Working Document

Limit of scope for UVU between R1253 and R327

1. <u>Purpose of the contribution :</u>

3.1.Example of Plug fan

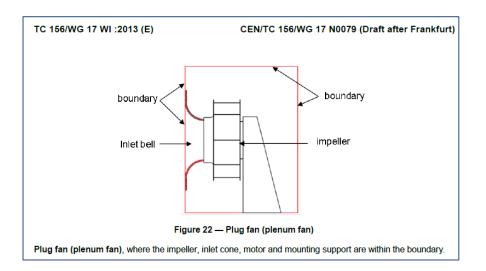
Slide n°14, example 4, presents a plug fan inside a box.

This plug fan is the same as the one shown in example 3: fan without housing, which shall comply with R327.

Therefore if we had a physical layer out of this "fan without housing", (becoming example 4), this is then a "fan without housing, with a casing" and shall comply with R1253. See below our proposal.

In the draft of the harmonized standard for R327, "**N0079_Draft after Frankfurt**", experts of CEN T156/WG 17 have worked on the boundaries of the fan configurations for the tests. Note that in this document the red lines are "Virtual" lines which do not always correspond to a physical layer. In this document Figure 22 (see below) presents the same configuration as in examples 3 and 4 of DTI presentation (2-UVU), i.e, a plug fan. The red line of the boundary in Figure 22 does not lay on a casing. This clearly shows that example 3 is under R327 and example 4 is not under R327.
